DCN No. **E980235-A-D**

DOCUMENT CHANGE NOTICE (DCN)

DOCUMENT No. (DOC-REV-GP. ID)	TITLE	NEW REV.
D980235-A-D	Ribbon Cable Clamp	B

-1 BASE
MAT'L: 6061-T6 ALUMINUM

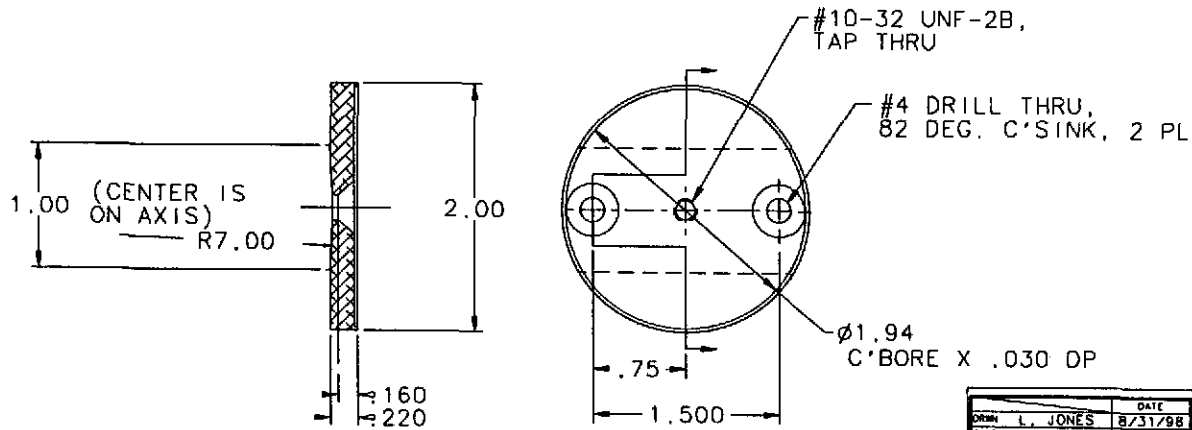
1. Added "dash numbers" to parts names
2. Removed .100" deep groove from Adapter (-2), as it's no longer needed.
3. Corrected graphical representation of back side of Adapter.
4. Modified width of Base (-1) to suit use of Base without Adapter
5. Changed material of Liner (-4) from Viton to Flourel; added spec.
6. Increased font size for legibility, all parts.
